# Updated Proposal for a 1 Gb/s LS path with 7.5Gb/s or 5Gb/s HS path

June 16, 2026

Ad-hoc

# 1Gbps Bursts in LS Path with 7.5Gbps or 5Gbps Bursts in HS Path

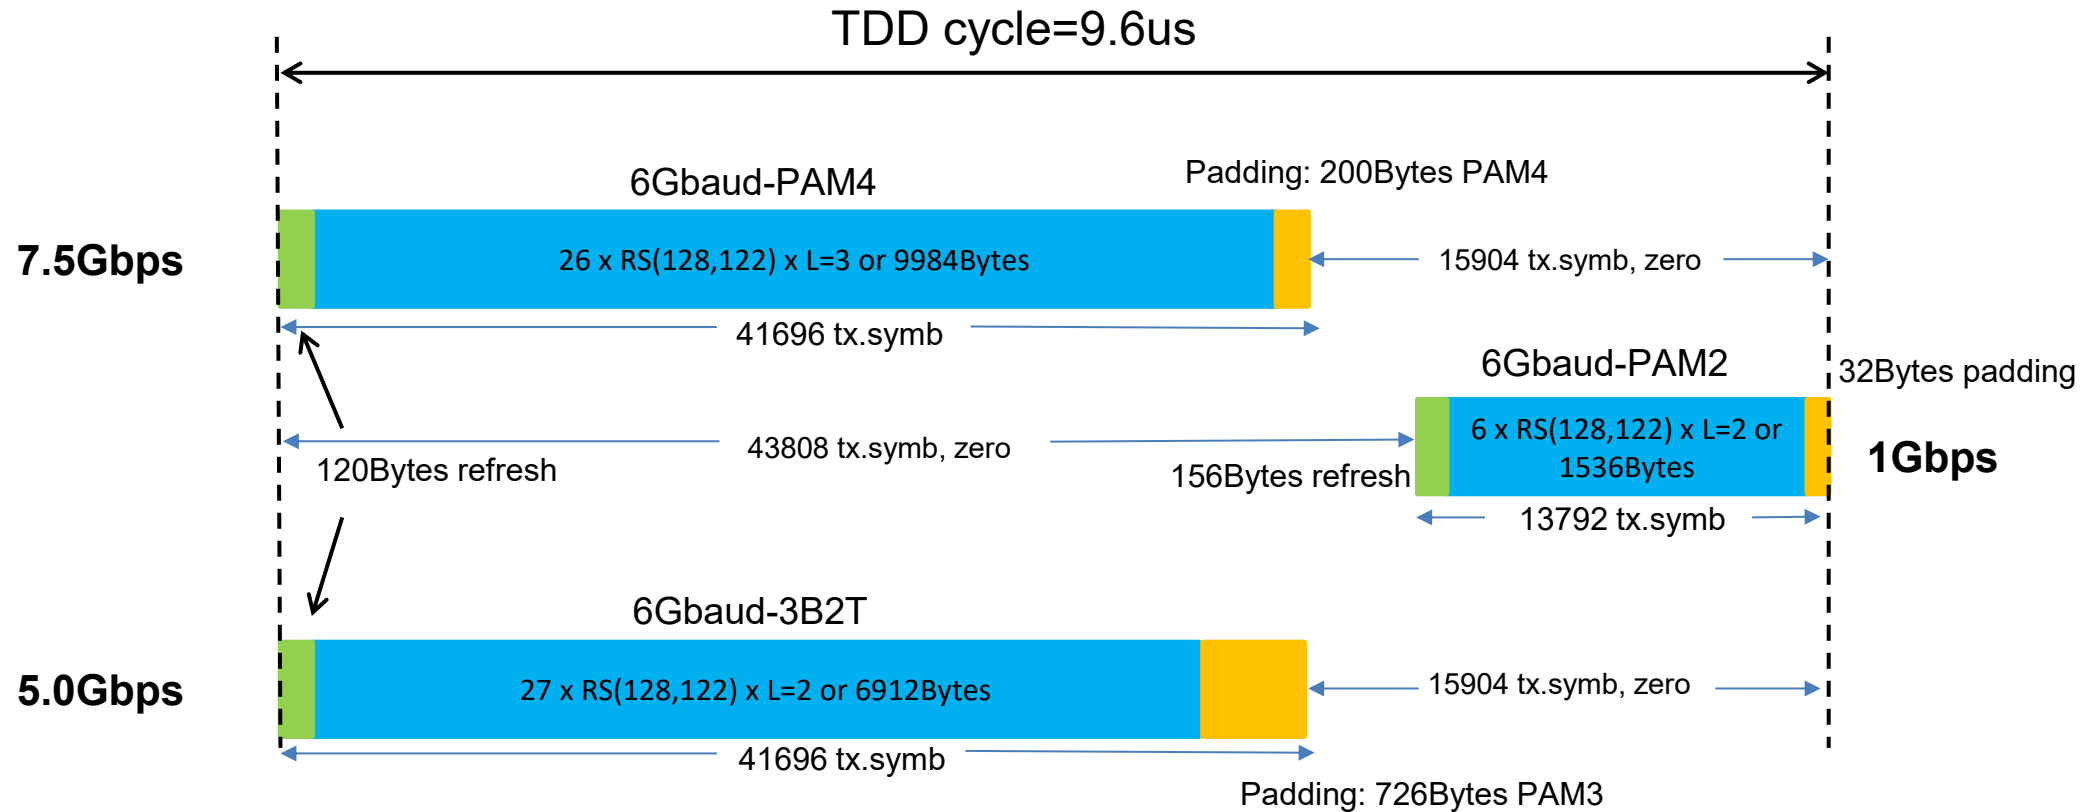
## HS path: 5Gbps

6Gbaud-PAM3(3B2T), 25 x RS (128,122), L=2.

This is same as HS 5Gbps specification other than the scrambler and modulation that follows HS 7.5Gbps and a shorter burst duration of 5688.88ns.

## Additional Capacity

There is a 1484.44ns extra capacity;

Add 1 x RS (128,122), L=2 to LS path plus a padding of 32Bytes

Add 2 x RS (128,122), L=2 to HS path plus a padding of 726Bytes

\* There is an extra coded capacity in all three bursts which is proposed to be used for other user-defined purposes.
